# Technical Service Bulletin

**Cobra Motorcycle Mfg.**

## TSB2212 King and JR Intake Screws Re-tightening

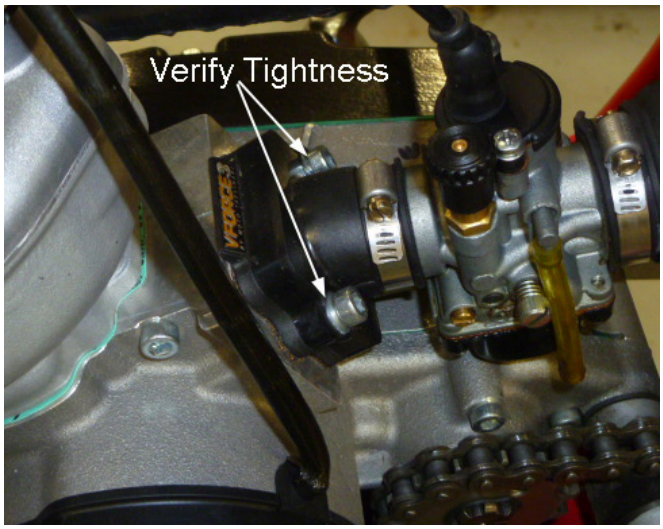
The two socket head cap screws that secure the intake boot to the engine on the 2012 King and CX50 JR may require retightening over time. The proper torque is 4.5 ft-lb (55 in-lb, 6 Nm). Insufficient tightness on these screws may cause an air leak.
